Subject: Brunswick Steam Electric Plant, Unit Nos. 1 and 2
Docket Nos. 50-325 and 50-324/License Nos. DPR-71 and DPR-62
Response to Request for Additional Information
Relief Request RR-34, Control Rod Drive System Hydraulic Lines

Response to Request for Additional Information - Request No. RR-34

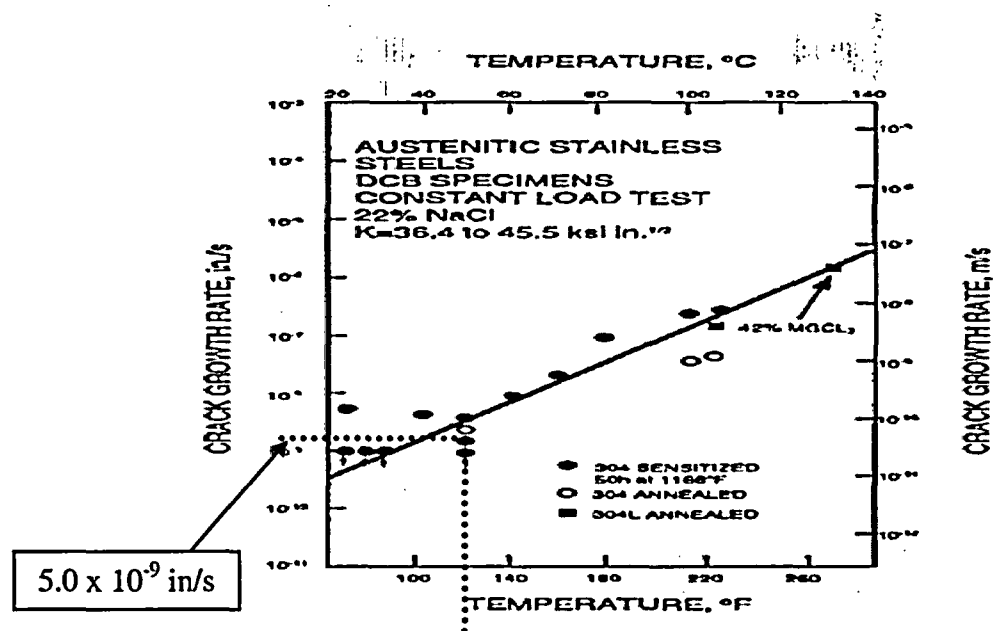
Enclosure 1 of BSEP 04-0146 page 6 of 7, last paragraph. This paragraph discusses assumed growth rate. The growth rate is not that of a saltwater environment. Provide data that demonstrates the assumed rate is conservative.

PEC has determined that use of a 5×10^{-5} in/hr crack growth rate in this application is conservative. Stress corrosion cracking (SCC) of stainless steels due to concentration of chlorides during "dryout" is discussed in EPRI Final Report 1002792, "Materials Handbook for Nuclear Plant Pressure Boundary Applications, December 2002." It is well known that austenitic stainless steels are susceptible to chloride induced SCC, even at ambient temperatures, when subjected to chloride bearing environments followed by dryout. The effects of chloride concentration and exposure time on susceptibility of 304 stainless steel to chloride induced SCC under dryout conditions were researched in A. J. Sedriks, "Stress Corrosion Cracking of Stainless Steels," *Stress Corrosion Cracking*, R.H. Jones, ASM International, 1992, which is applicable to the conditions experienced by the affected CRD hydraulic lines.

The results of this research is summarized in the graph above (from page (I) 3-63 of EPRI Final Report 1002792), showing the effect of temperature on crack growth rate in highly concentrated chlorides, noting that most of the data is for sensitized 304 stainless steel. Using the normal service temperature of the CRD insert and withdraw lines of 120°F and converting to in/hr, a crack growth rate of 1.8×10^{-5} in/hr is estimated which is a factor of 2.8 less than the crack growth rate of 5.0×10^{-5} in/hr used in the structural integrity evaluation. This crack growth rate taken from the graph above is considered to be conservative for the following reasons:

1. Chlorides produced in laboratory tests are typically more concentrated than actual conditions.
2. Efforts to clean the surfaces where defects were discovered were performed.
3. No further wetting of the surface is expected since the source of chloride contamination has been stopped and surfaces inside the crack should remain dry.

Therefore, the 5×10^{-5} in/hr crack growth rate used in the structural integrity evaluation is bounding based on data that is more representative of the actual condition of the CRD hydraulic lines.
